Site Accessibility Evaluation

**Work Net Office Building
Suites 102-133**

**543 W Grant Line Rd
Tracy, CA 95376**

Inspection Date: 11/14/2016

Finding: 2

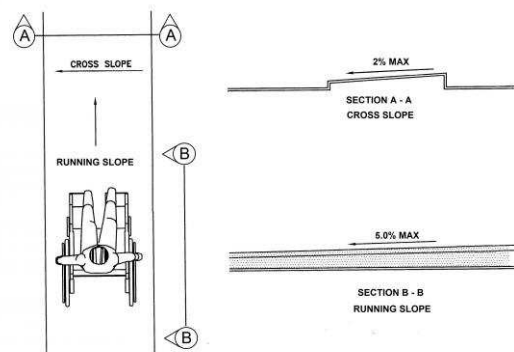
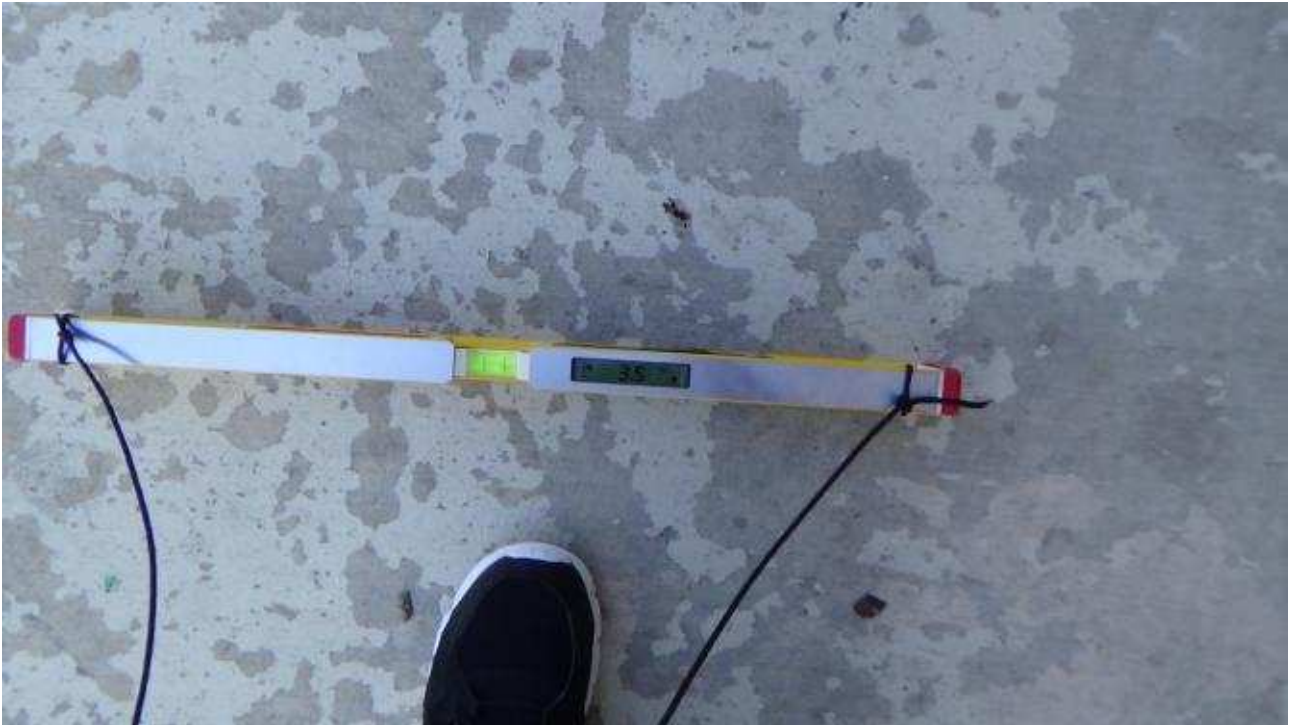
The accessible route of travel between the building and the public way on the site contains cross slopes greater than 2%.

2.5% - 3.5% (10 panels)

Remove and replace all non-complaint concrete panels. Services of a Licensed Architect, Registered Engineer or Licensed Contractor may be required.

Finding: 3

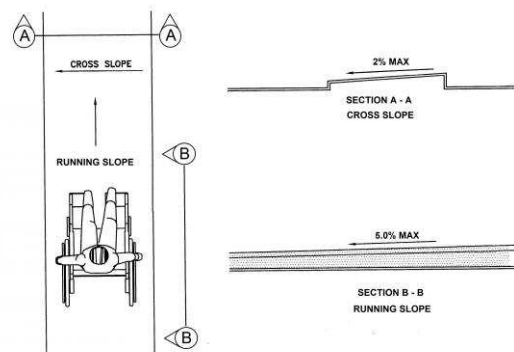
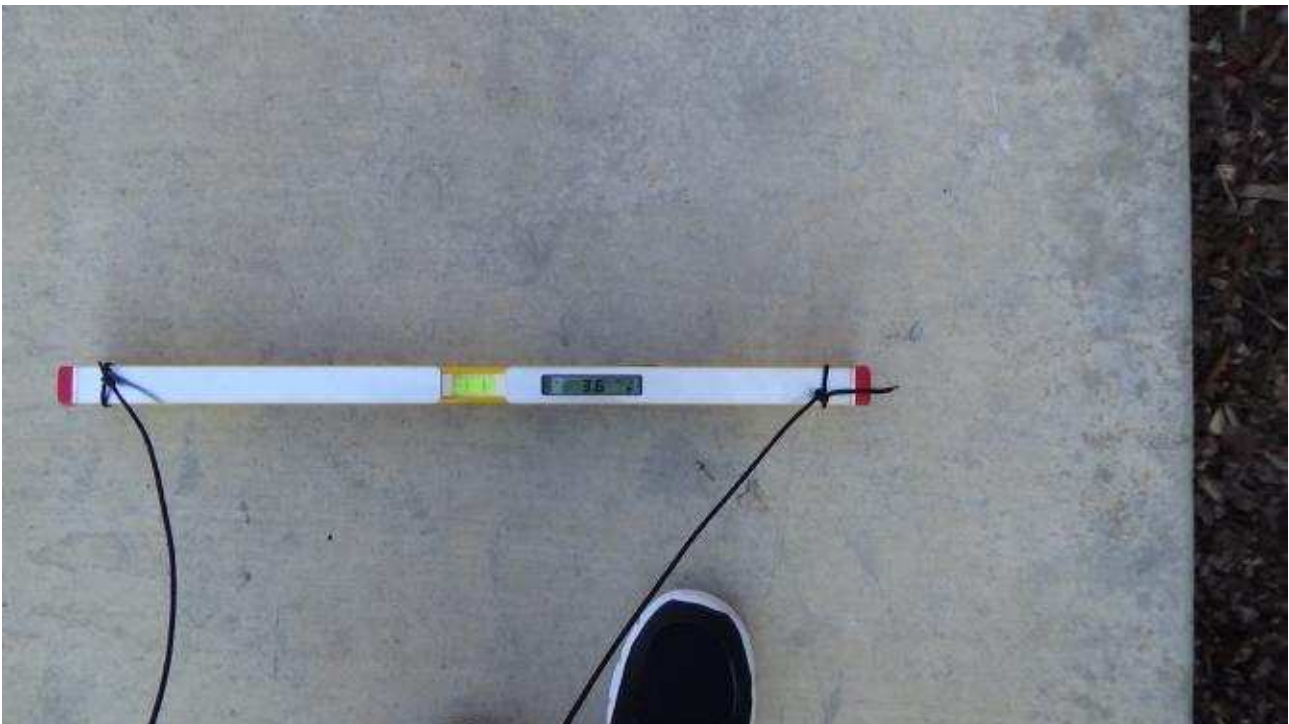
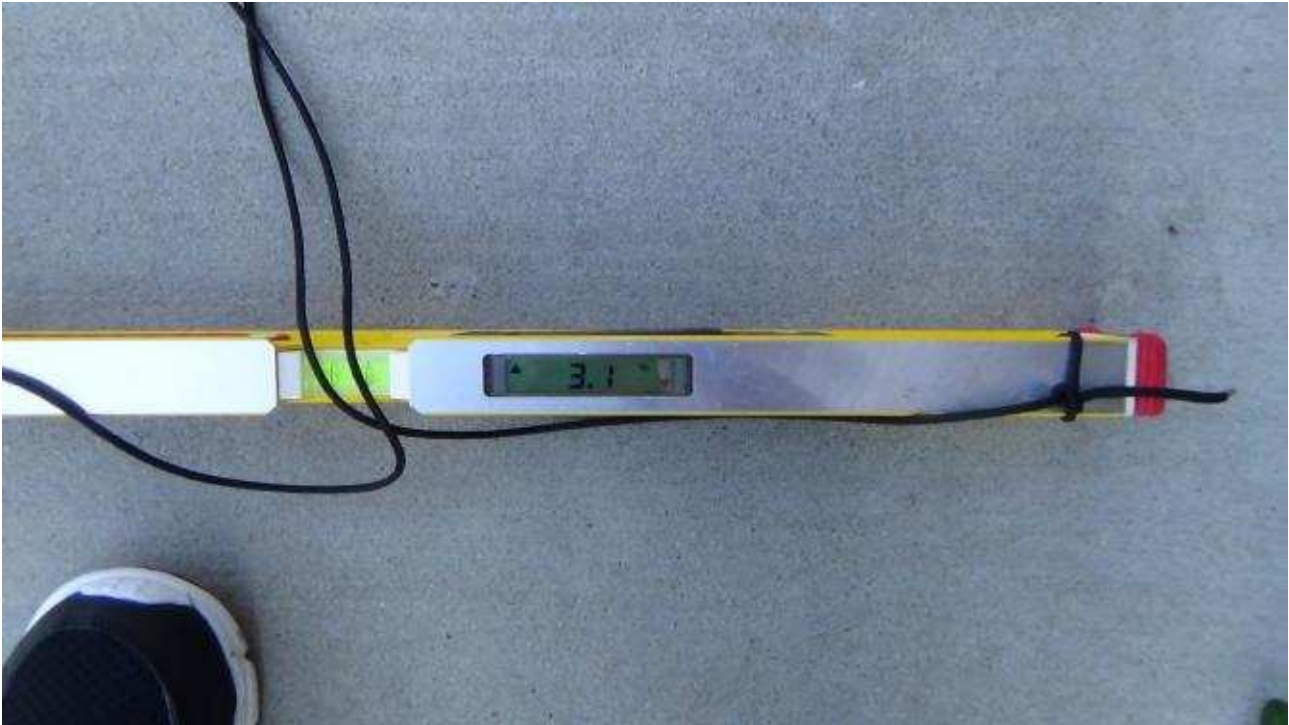
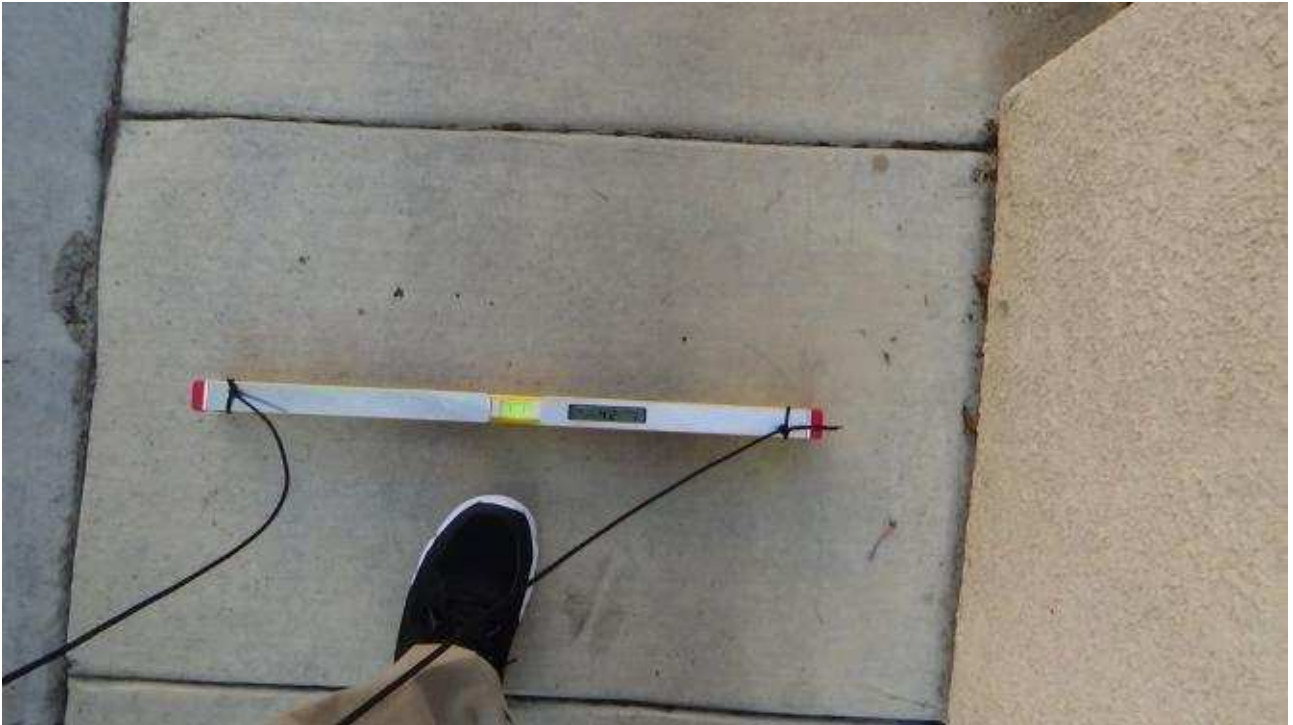
The accessible route of travel between the building and the public way on the site contains cross slopes greater than 2%.

2.5% - 4.9% (44 panels)

Remove and replace all non-complaint concrete panels. Services of a Licensed Architect, Registered Engineer or Licensed Contractor may be required.

Finding: 4

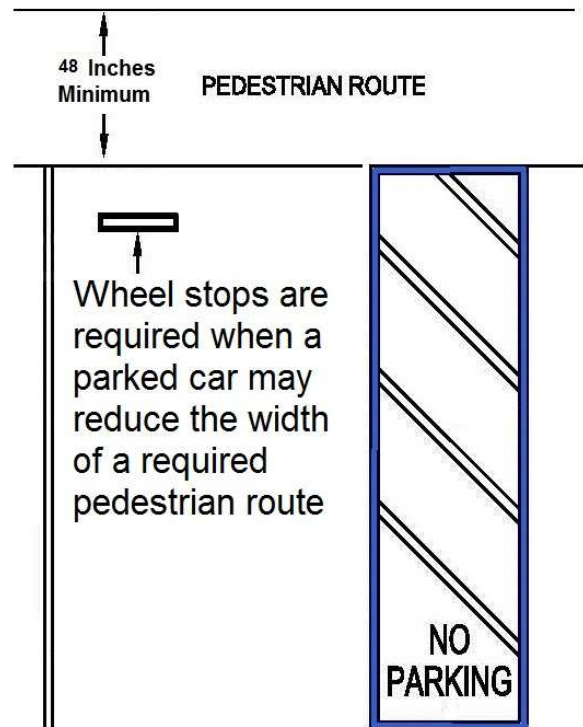
Parked vehicles shall not reduce the required width of the accessible route.

<48"

Install wheel stops at all parking stalls along the path of travel (walk).

Finding: 5

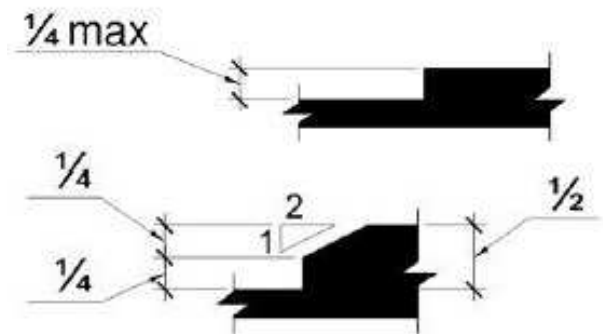
The clear floor space required at the bike rack has a change in elevation and large gaps.

3/4" - 1 1/2"

Remove and replace electrical subgrade box cover.

Finding: 6

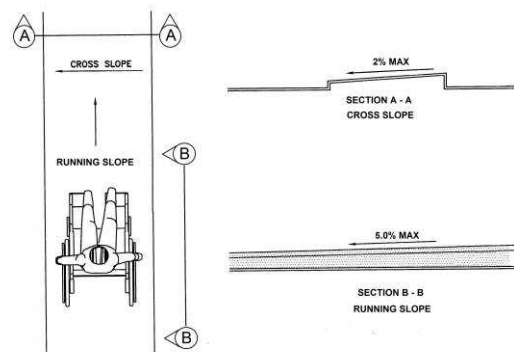
The accessible route of travel between the building and the public way on the site contains cross slopes greater than 2%.

2.5% - 3.2% (1st 6'-8')

Remove and replace all non-complaint concrete. Services of a Licensed Architect, Registered Engineer or Licensed Contractor may be required.

Finding: 7

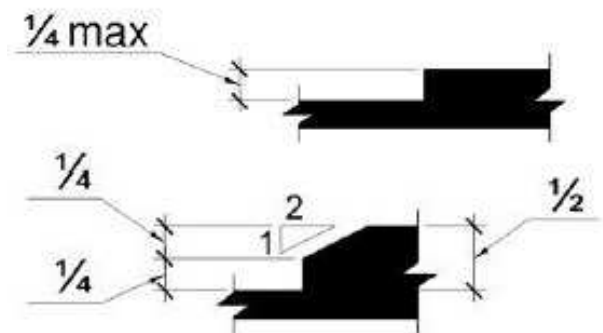
The walkway contains abrupt vertical edges and/or variations over a 1/4 inch.

3/4" - 1"

Smooth out abrupt-edge transition to within a 1/4". Edge treatment recommended.

Finding: 9

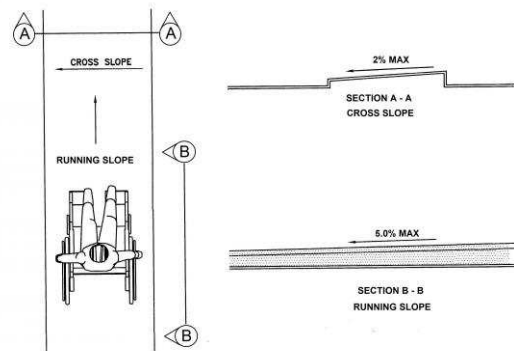
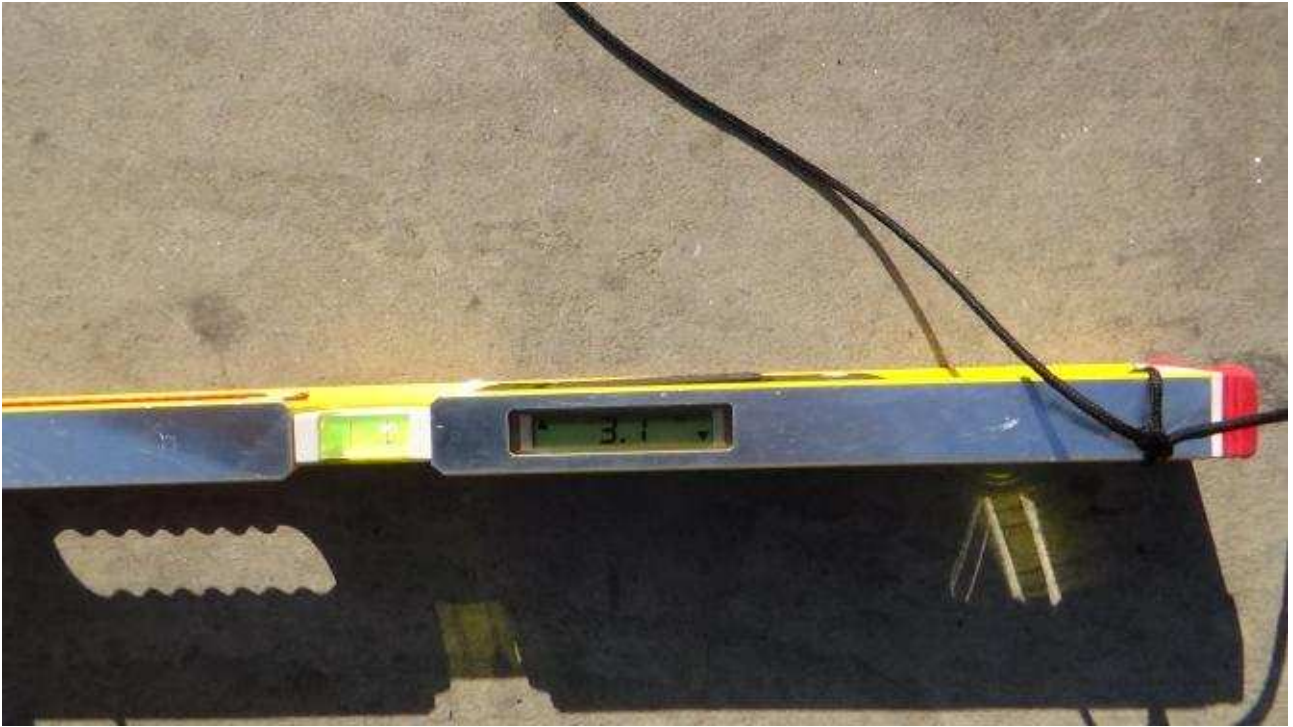
The ramp on the accessible route contains cross slopes greater than 2%.

2016 CBC 11B Section: 11B-405.3	2.6% - 3.1% (1 panel)	\$1500.00 - \$6500.00
---------------------------------	-----------------------	-----------------------

Remove and replace all non-complaint concrete panels. Services of a Licensed Architect, Registered Engineer or Licensed Contractor may be required.

Finding: 10

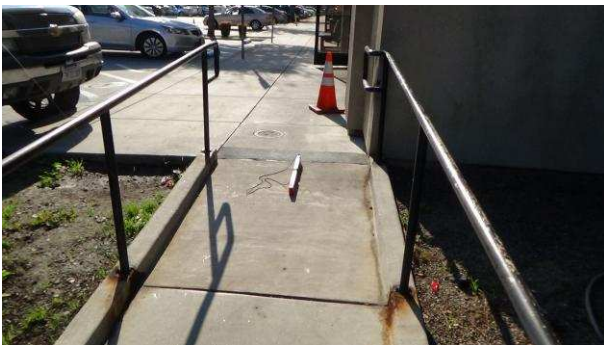
The ramps slope exceeds the maximum running slope (direction of travel) allowable of 8.33%.

2016 CBC 11B Section: 11B-405.2	8.8% - 9.6% (1 panel)	\$1500.00 - \$6500.00
---------------------------------	-----------------------	-----------------------

Remove and replace all non-complaint concrete panels. Services of a Licensed Architect, Registered Engineer or Licensed Contractor may be required.

Finding: 12

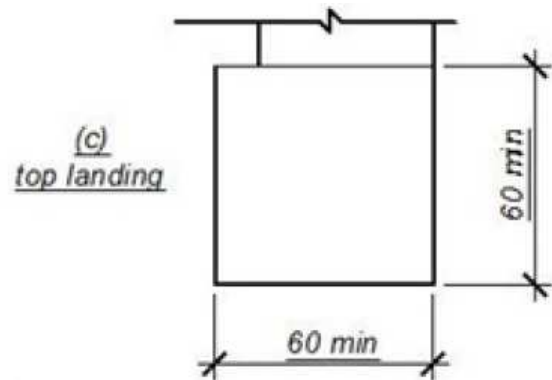
The top landing of the ramp is not the correct size.

<60" at 7" wall "jog"

Widen top panel of ramp to accommodate wall jog. Services of a Licensed Architect, Registered Engineer or Licensed Contractor may be required.

Finding: 14

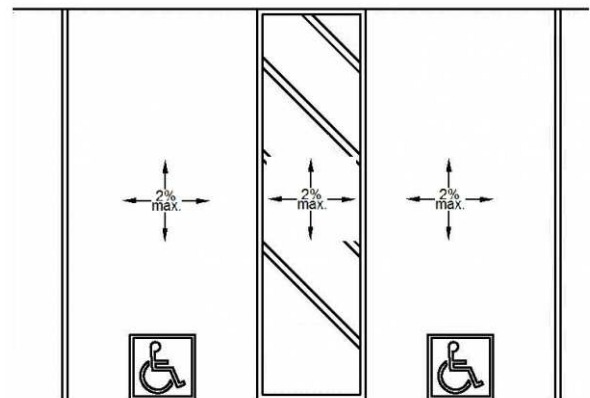
The accessible parking stall's access aisle contains a built up curb ramp which results in significant slopes greater than 2 percent.

7.4% - 27.2%

Remove concrete built up curb ramp from parking stalls and access aisle and replace with a compliant curb ramp such as a parallel curb ramp. Services of a Licensed Architect, Registered Engineer or Licensed Contractor may be required.

Finding: 15

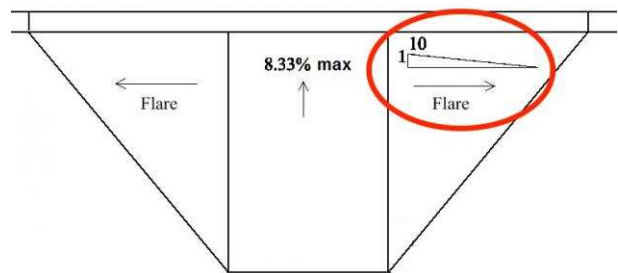
The curb ramp side flares are too steep.

27.2%

Remove concrete built up curb ramp from parking stalls and access aisle and replace with a compliant curb ramp such as a parallel curb ramp. Services of a Licensed Architect, Registered Engineer or Licensed Contractor may be required.

Finding: 16

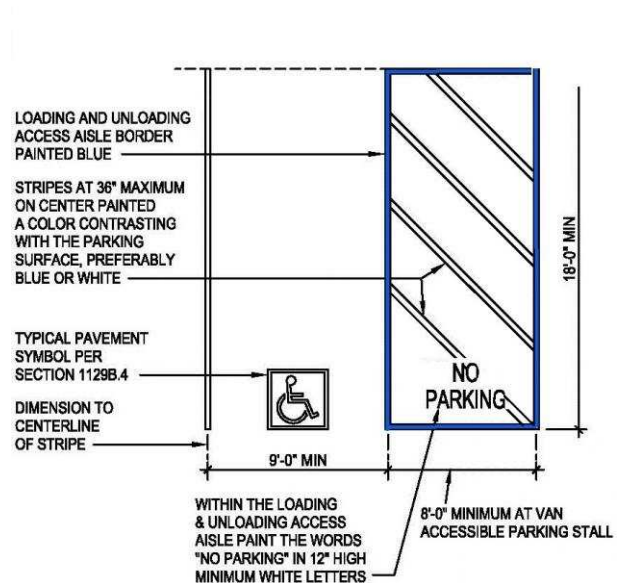
The access aisle is not a minimum 8 feet wide.

7' 10 1/2"

Restripe the access aisle to a minimum 8' to the center of the stripes.

Finding: 17

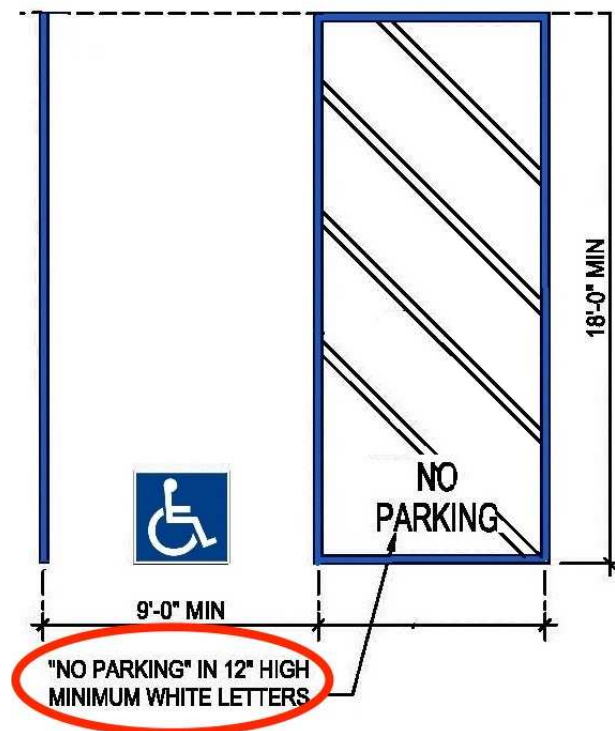
The words "No Parking" in the access aisle are not the correct size.

11"

Repaint the letters "No Parking" to a minimum 12" or larger.

Finding: 18

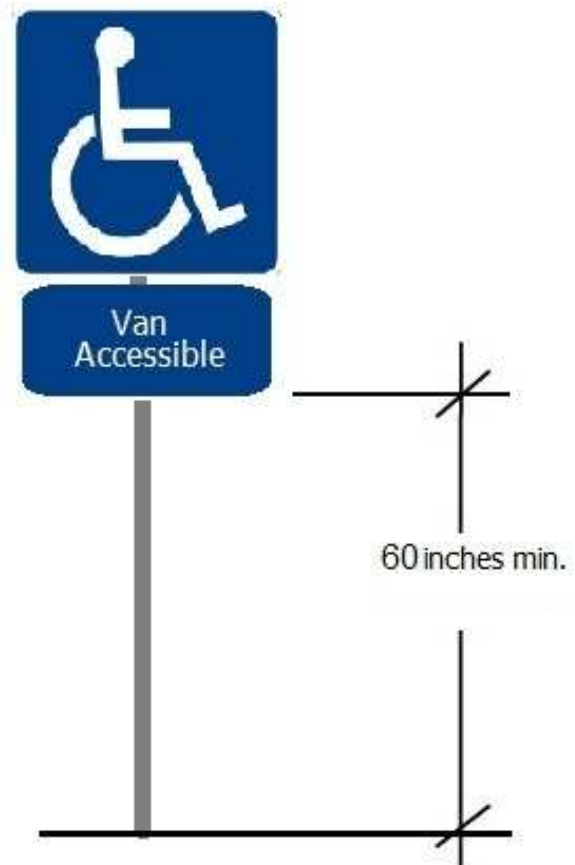
The parking signs are mounted too low.

46" - 47 3/4"

Relocate/raise both signs to a minimum 60"

Finding: 19

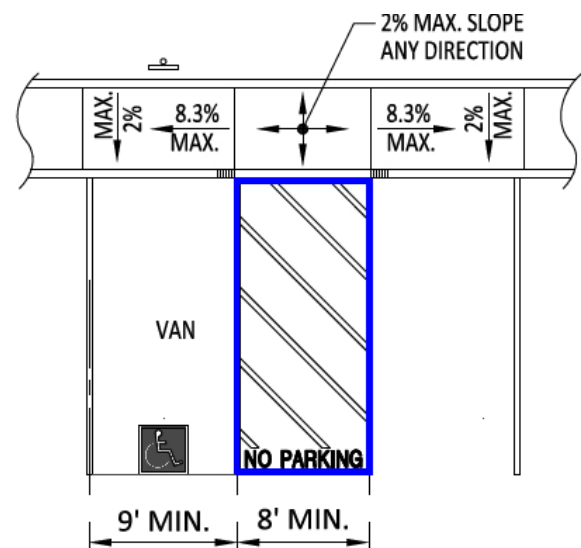
The access aisle is not outlined with a blue border.

Missing on all edges

Install blue border around all edges of the access aisle.

Finding: 22

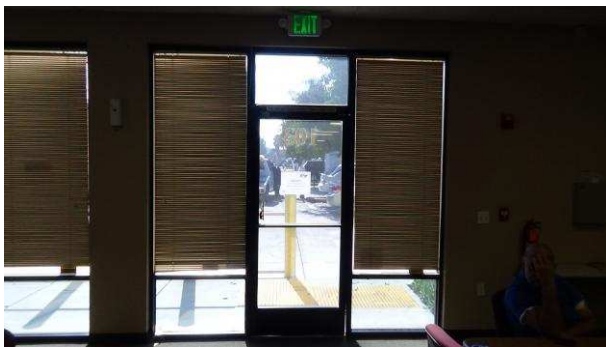
A tactile EXIT sign is missing at each entrance door.

None

Install tactile exit sign adjacent to each door as specified.

Finding: 24

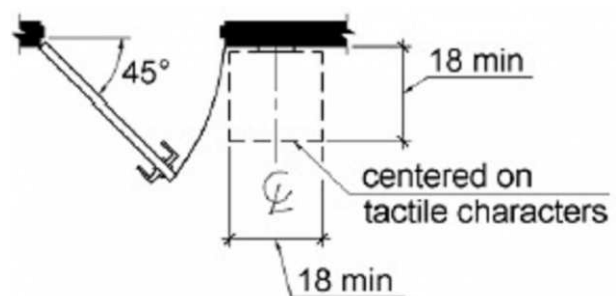
The tactile EXIT sign is obstructed by blinds at the door.

Obstructed by blinds

Remove blinds so that they do not obstruct the tactile exit sign.

Finding: 25

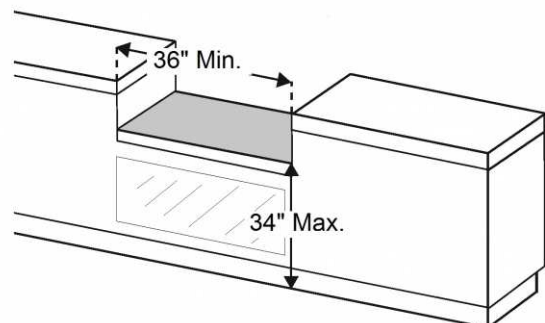
The sales and service counter is provided but is obstructed and being occupied by marketing materials which make it unavailable for persons with disabilities.

Obstructed by
marketing materials

Remove all marketing material from the lower accessible counter area.

Finding: 26

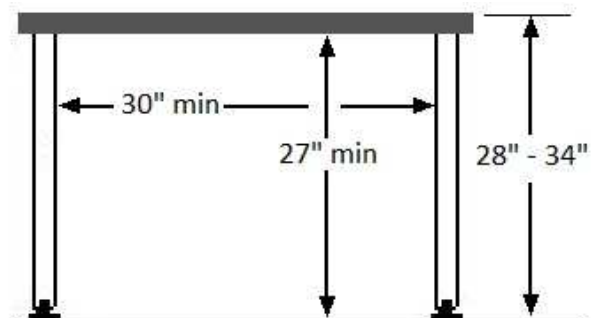
There are approximately 24 workstations with computers which require 2 accessible workstations. Only 1 has been provided.

1 non functional work station (2 req.)

Provide a second fully accessible workstation equivalent to and with the same functionality as the 24 none accessible workstations. (ie computers, phones, connections, support and other amenities).

Finding: 27

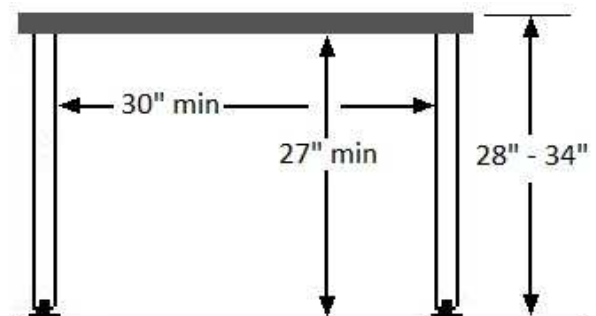
There was 1 accessible workstation in the seating area, however, the computers were not functional or working at the time of our inspection. 2 accessible workstations are required.

Not functioning

Provide 2 fully accessible workstations equivalent to and with the same functionality as the 24 non-accessible workstations. (ie computers, phones, connections, support and other amenities).

Finding: 28

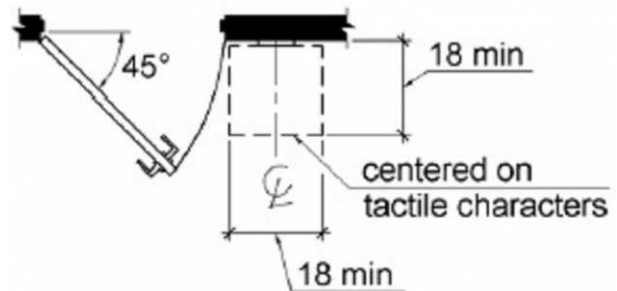
Clear floor space is not provide at the tactile door sign.

<9" from swing of the door.

Relocate sign a minimum 9" to the center of the sign from the swing of the door.

Finding: 29

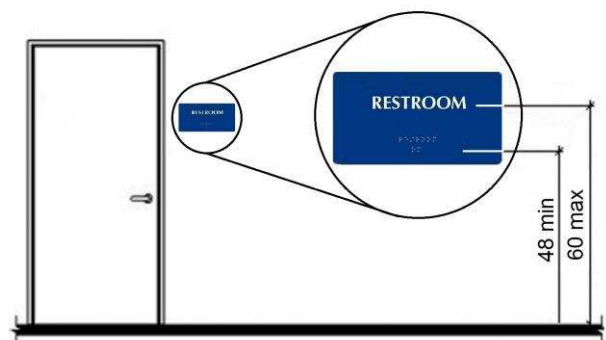
The sign is mounted too high.

60 1/2"

Relocate sign to correct height as specified.
